Indoor Station Firmware V2.2.2_build221129

Release Note (2022-12-02)

Device Model	DS-KH8350-WTE1, DS-KH8350-TE1, DS-KH6320-WTE1, DS-KH6320Y-WTE2, DS-KH6320-WTE2(B), DS-KH6320-TE1, DS-KH8520-WTE1
Firmware Version	V2.2.2_build221129
iVMS-4200	V3.8.3.1 or later

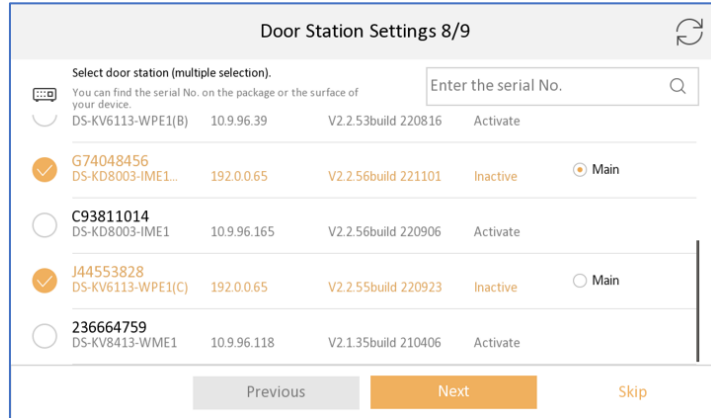
f. Main and sub door linkage

Note: the first selected door station will be the main, the second will be sub1, 3rd will be sub2, etc. Maximum select 17 door station at one time (1 main and 16 sub door stations)

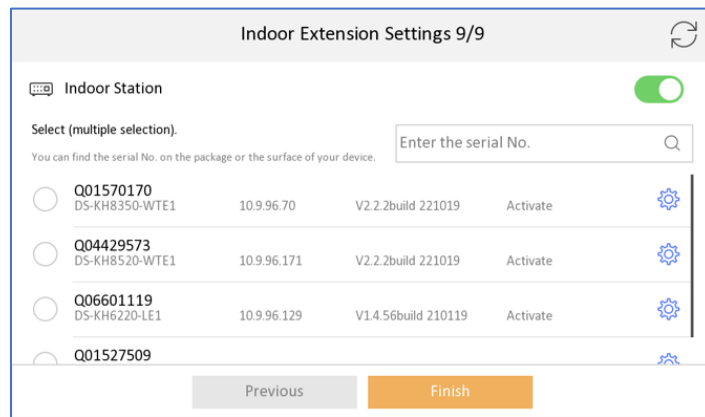
g. Indoor extension linkage

Note: the selected indoor station will be order and numbered as indoor extension 1,2,3... Maximum select 5 indoor extension at one time

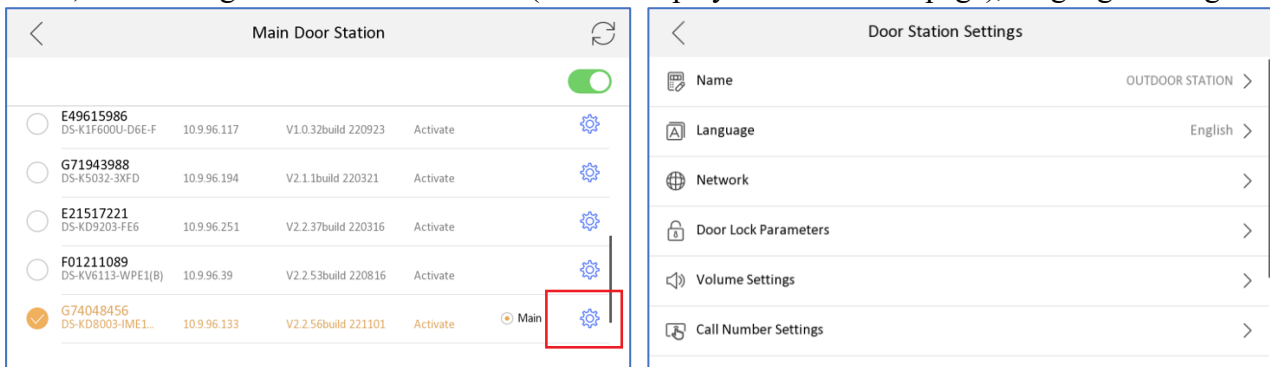
2. Configure the important parameters of door station from indoor station advanced settings menu (not from the wizard).

a) including the door station name (will be displayed in live view page), language setting

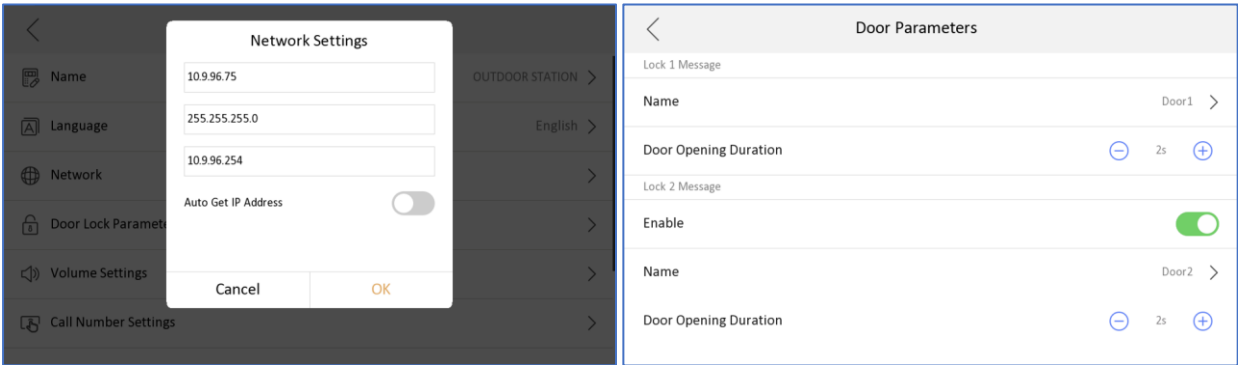
b) IP address, subnet mask, gateway, enable DHCP, lock name, door open duration, enable lock2, etc)

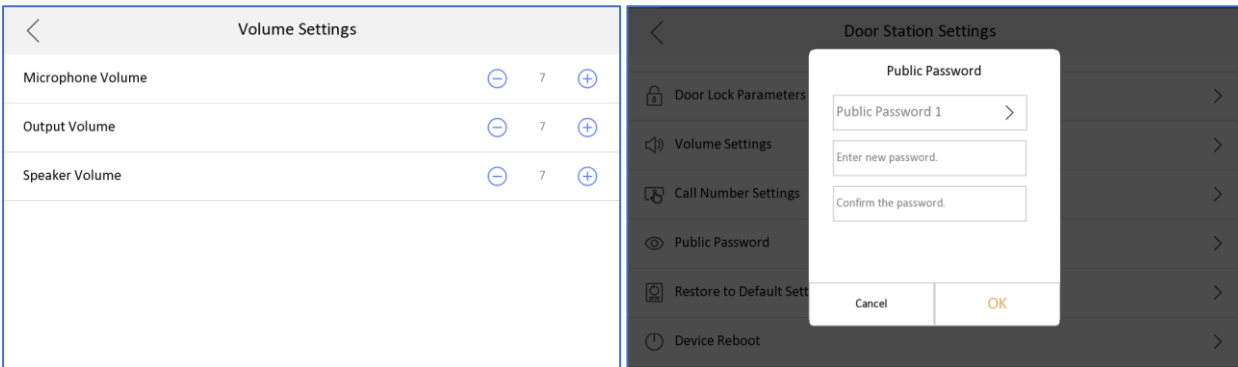
c) Volume setting, door station button call number, public password

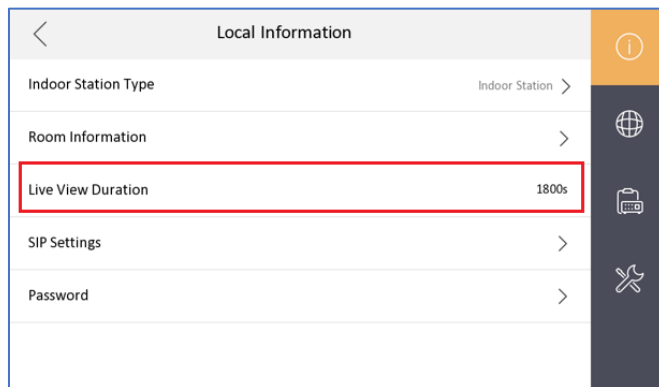
1. Door station and camera live view duration increase to 1,800s, range 10-1,800s, by default 30s.

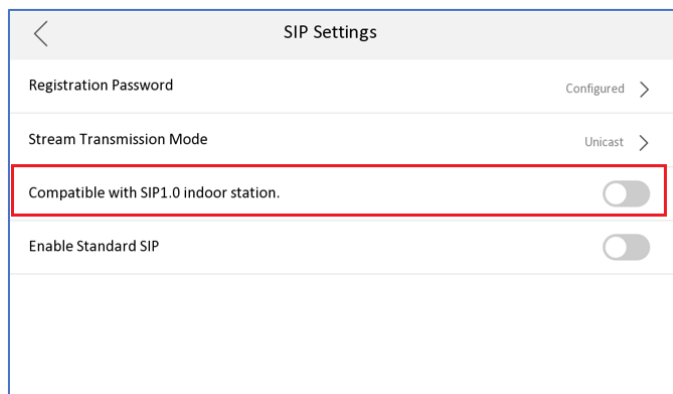
- Support switching between protocol 1.0 and 2.0, in default it's protocol 2.0
After enable, the indoor station is compatible with protocol 1.0 indoor extension.

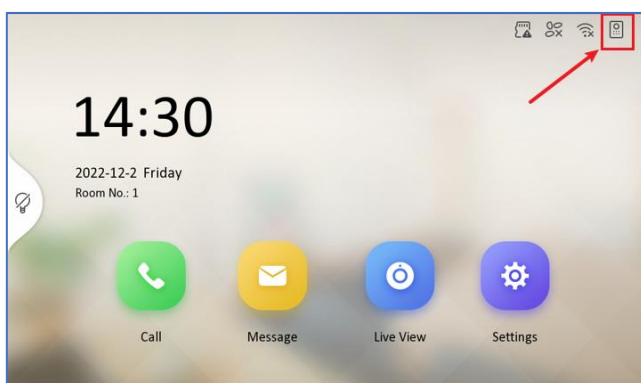
- Optimized the icon of door station registration status in the main UI up right corner.

Before	Now
Indoor station registers to door station success		
Indoor station registers to door station failed		
Indoor station registers to door station and KM9503 success

Note: If the indoor station registers to door station failed, you can click this icon to register to door station manually, if still failed, It will indicate the reason for registration failure.

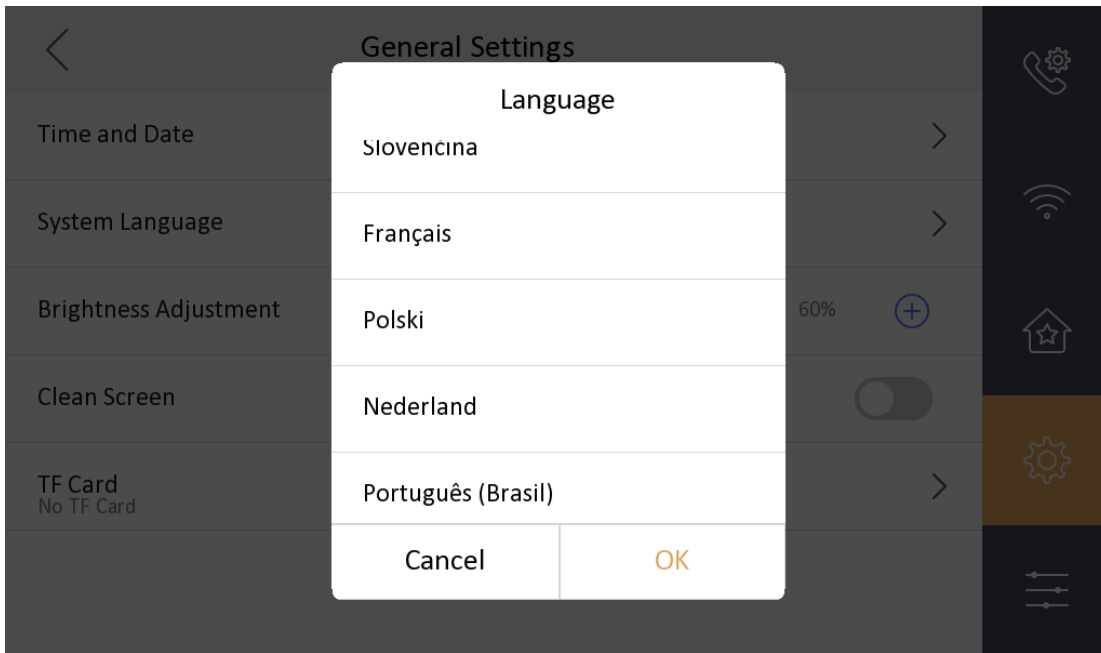
1. Supports static IP address

configuration of Wi-Fi (DHCP, IP address, subnet mask, gateway, DNS1, DNS2).

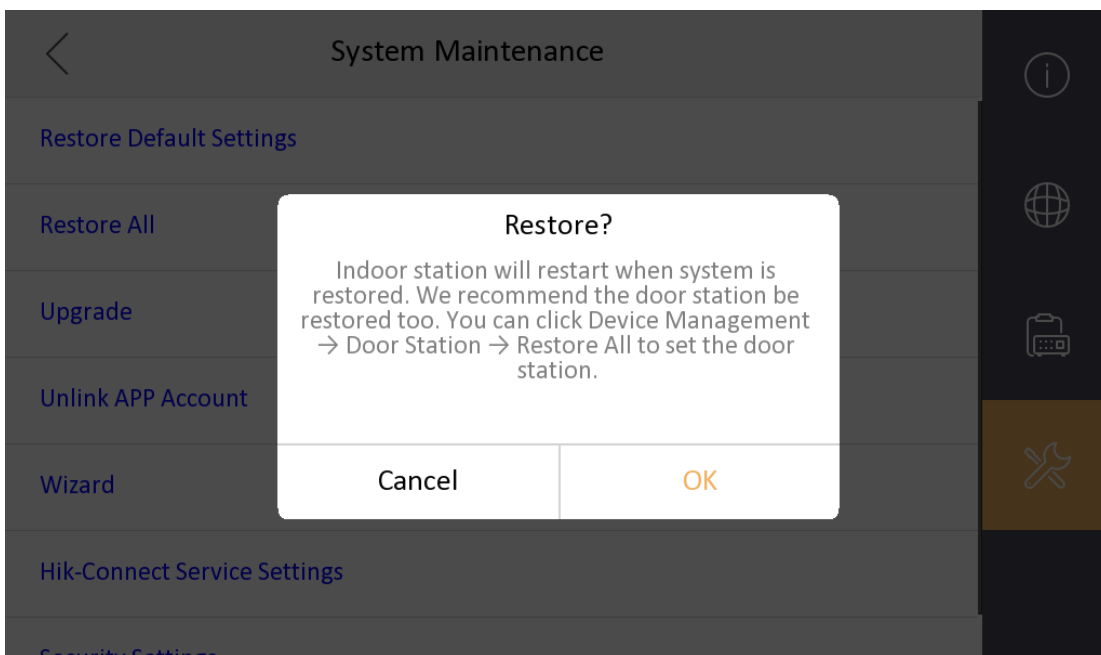
1. Optimizes the maintenance interface with a pop-up window when clicking **Restore** or **Restore All**.

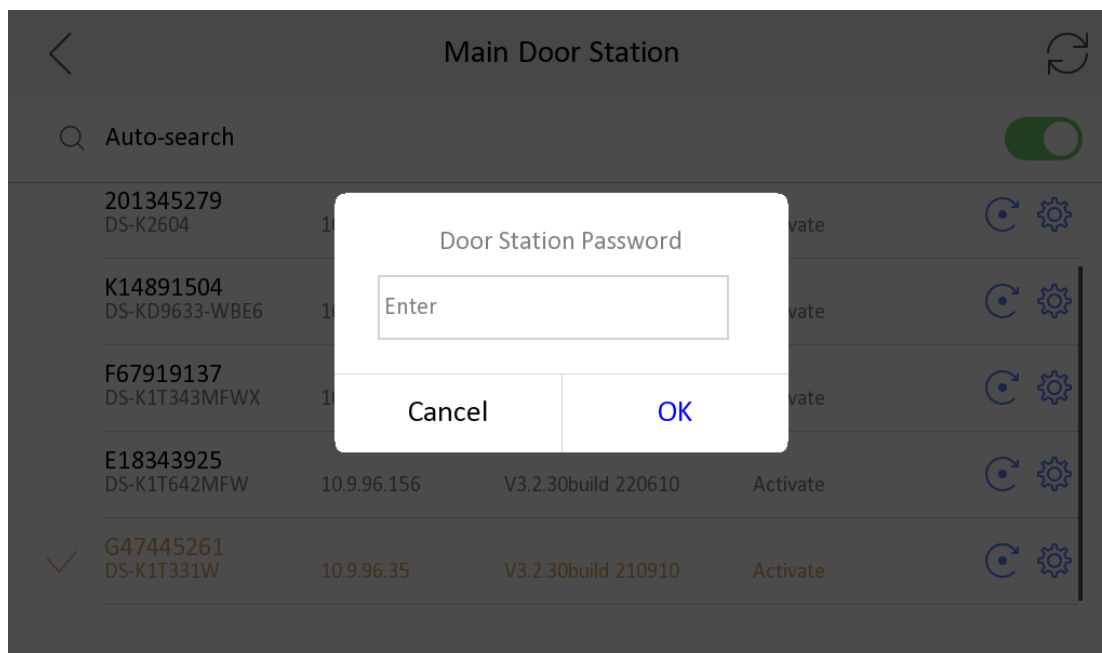
4. In configure wizard to related door station, when the door station password is different from the indoor station, prompt information will pop.

Wizard-Indoor Station Settings 3/5

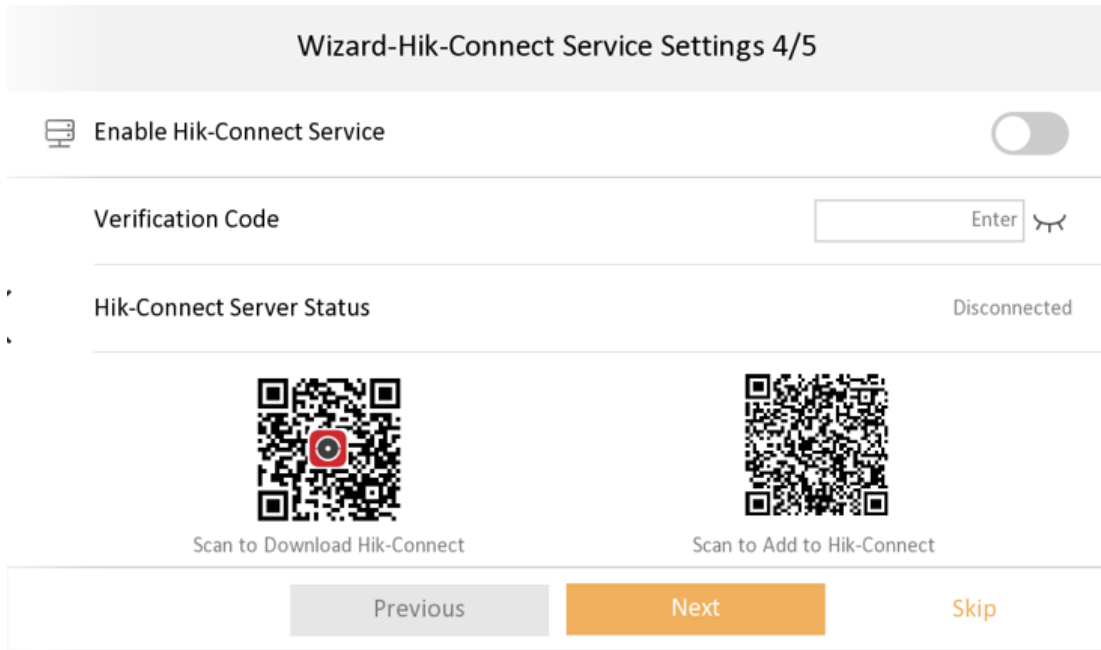
1. Optimize registration password settings in Wizard.

Registration Password Not configured. >
 Be consistent with the activation password.
When enabled, the people who has the registration password will have the device admin permissions.

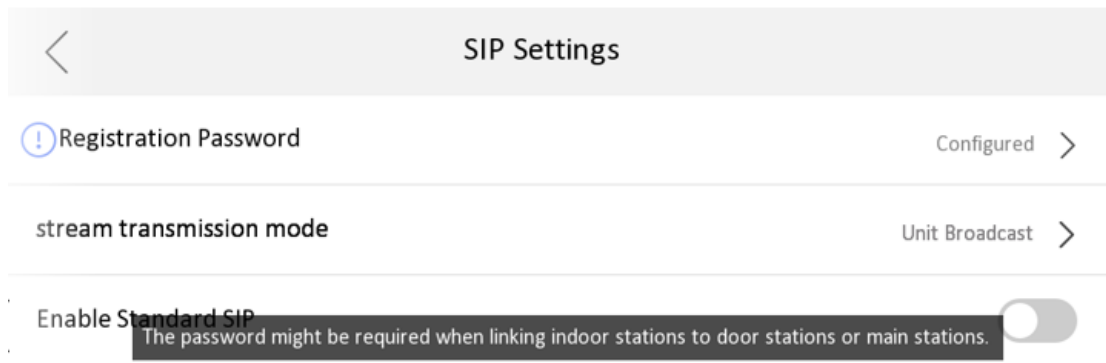
2. Optimize Hik-Connect password configuration page.

- 3. Support stream transmission mode settings, you can select Unit Broadcast or Group Broadcast.

Wizard-Hik-Connect Service Settings 4/5

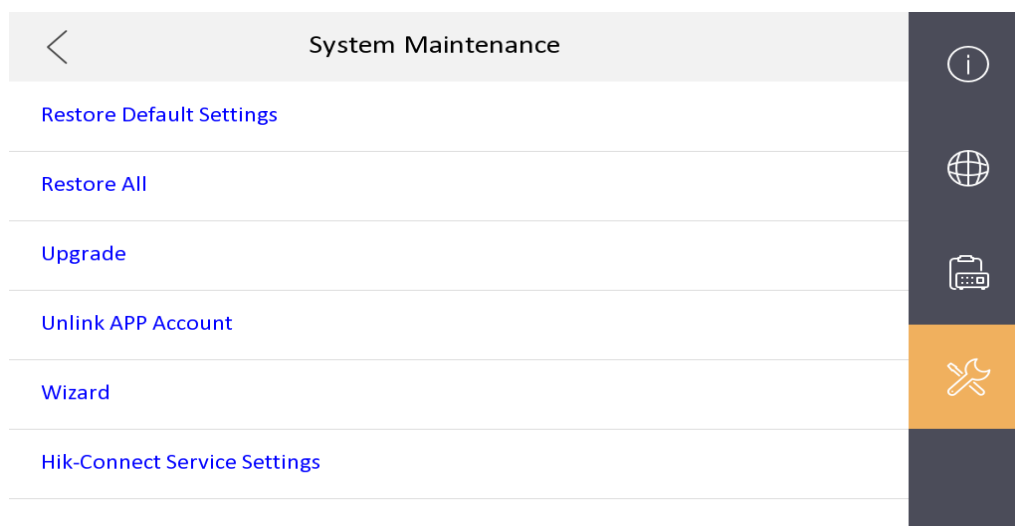
1. Verification code is empty by default.

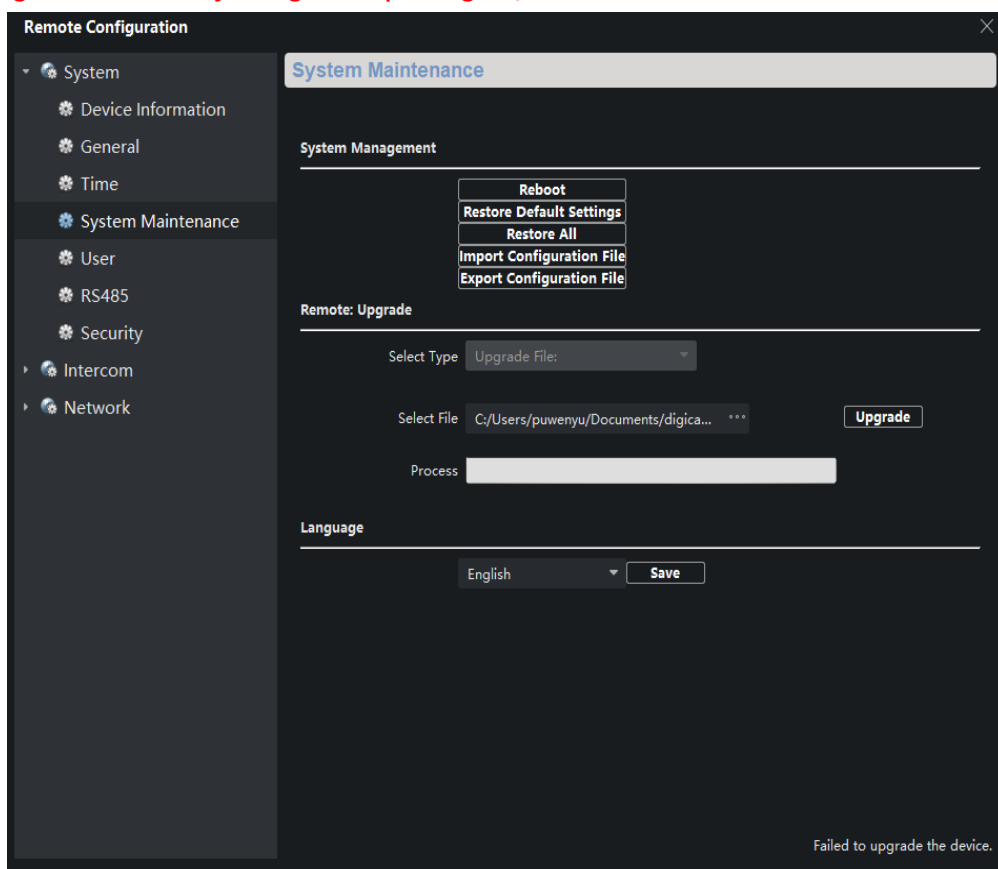
- Since **V2.1.24 build 210617**, remote

degradation of devices is not supported in all subsequent versions. When degradation occurs, it will prompt Failed to upgrade the device and the device will restart.

Notice: Although the device can be degraded by serial port, the device will fail to start and cannot change the version by using serial port again, which means that the device will be completely unusable.

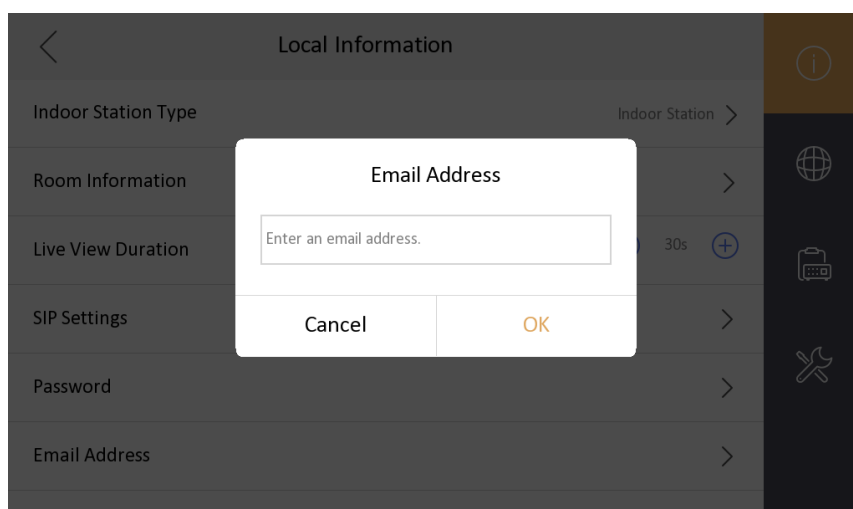
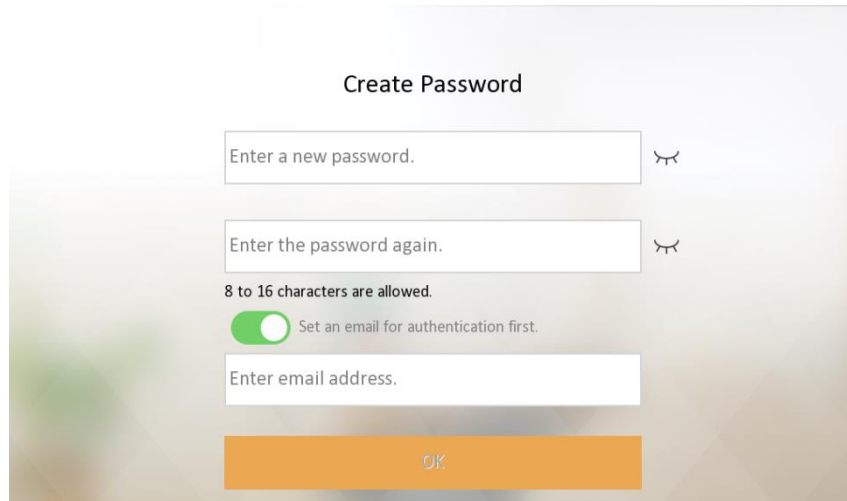
- 1. Local interface support to modify the password through email authentication

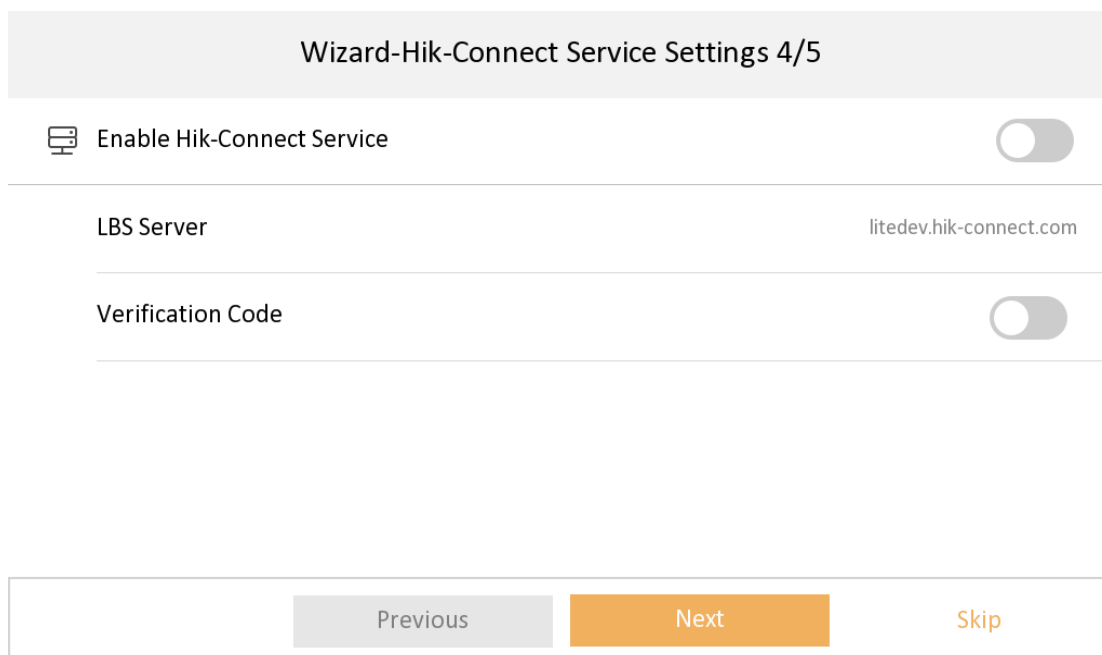
2. Support Hik-Connect configuration, closed by default

**Add Device**

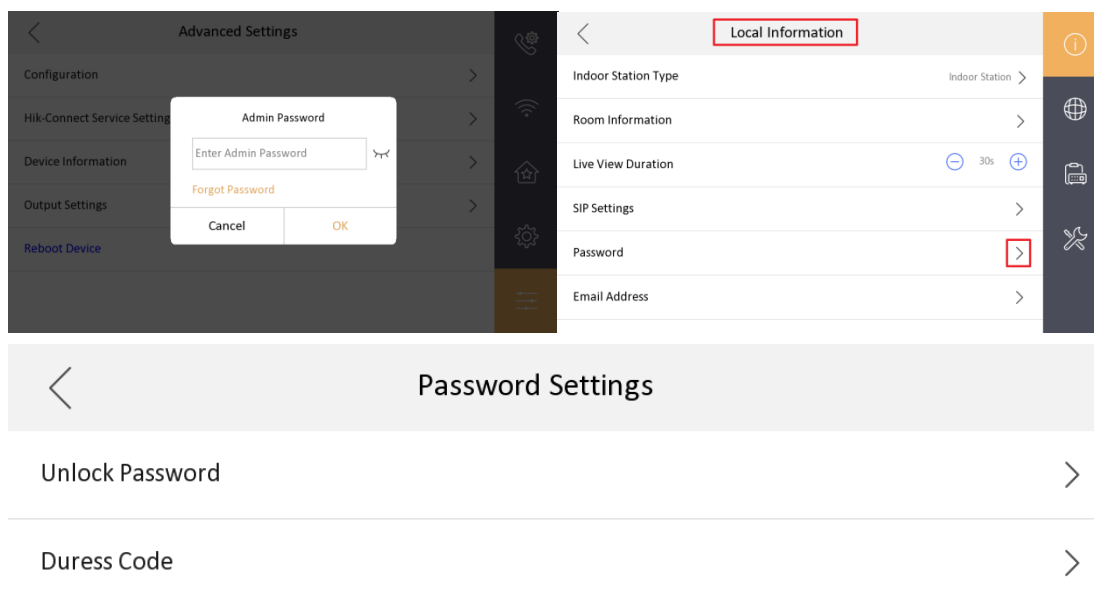
4. Add IPC interface, when Open Network Video Intercom protocol is selected, add plaintext ciphertext switch menu item configuration
